To: T10 Technical Committee
From: Rob Elliott (elliott@hp.com)
Date: 10 October 2007
Subject: 07-429r0 SAM-5 SCSI Initiator Port and Target Port capabilities attributes

Suggested changes to SAM-5 (based on sam4r13)

Figure 1 — SCSI Port class diagram [\[modified to add tons of attributes\]](#)

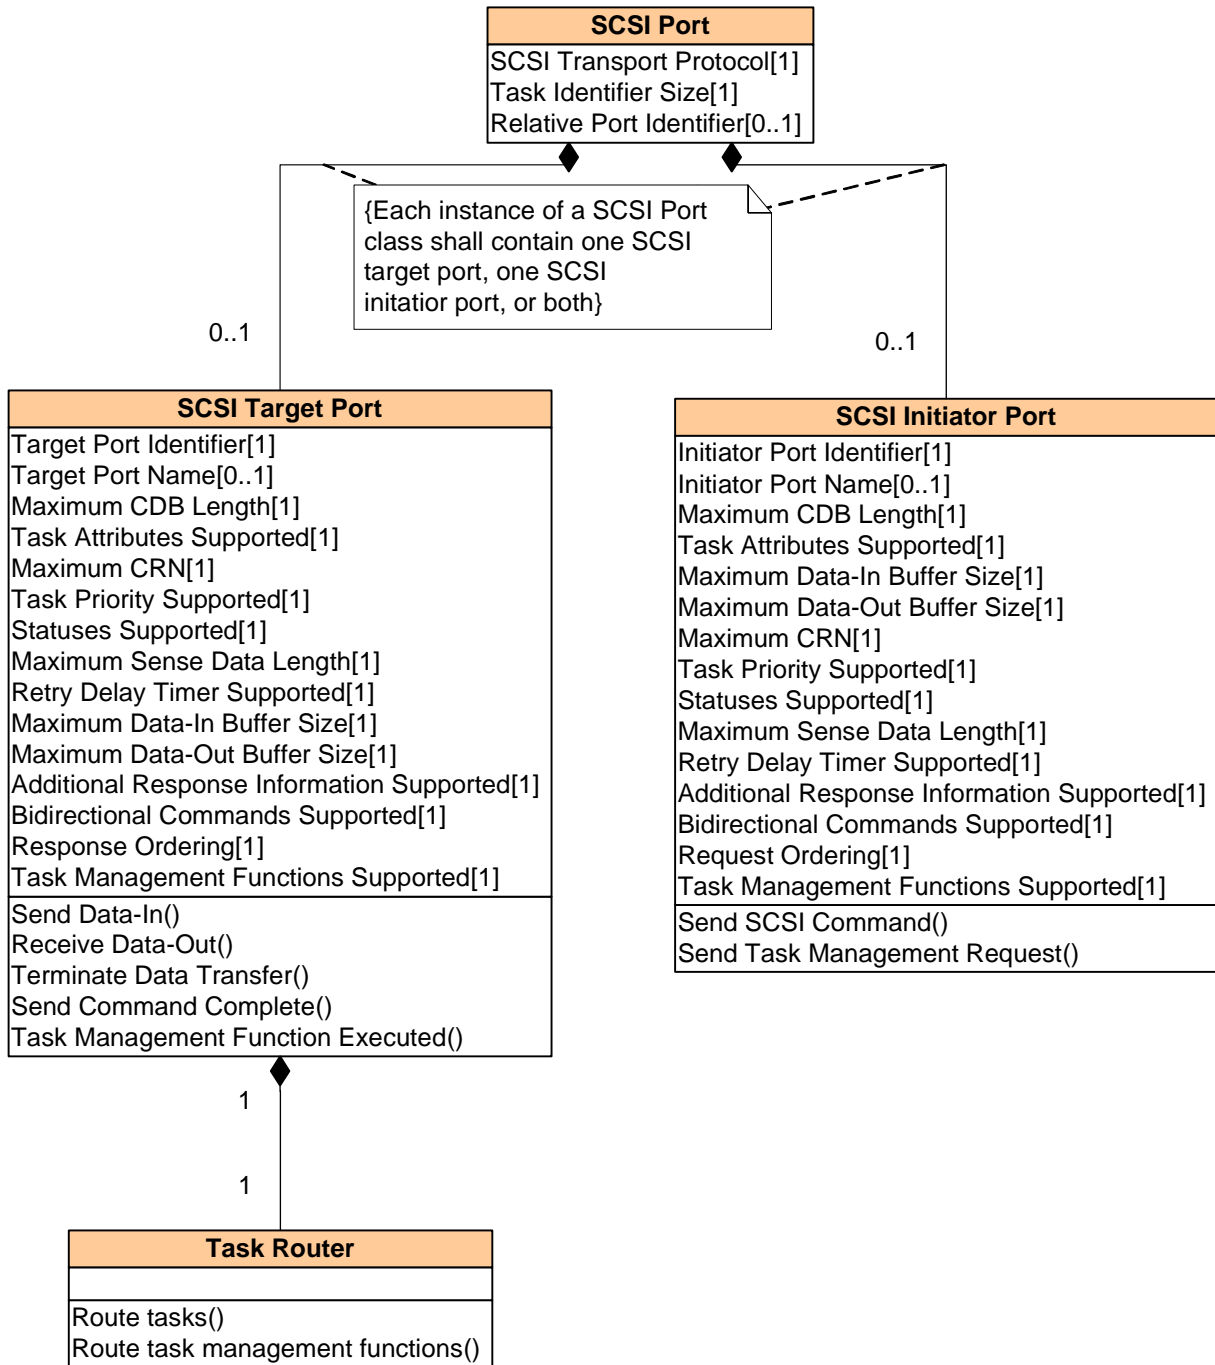
The SCSI Port class (see figure 18) contains the:

- a) SCSI Target Port class (see 4.5.6);
- b) SCSI Initiator Port class (see 4.5.7.1); or
- c) both.
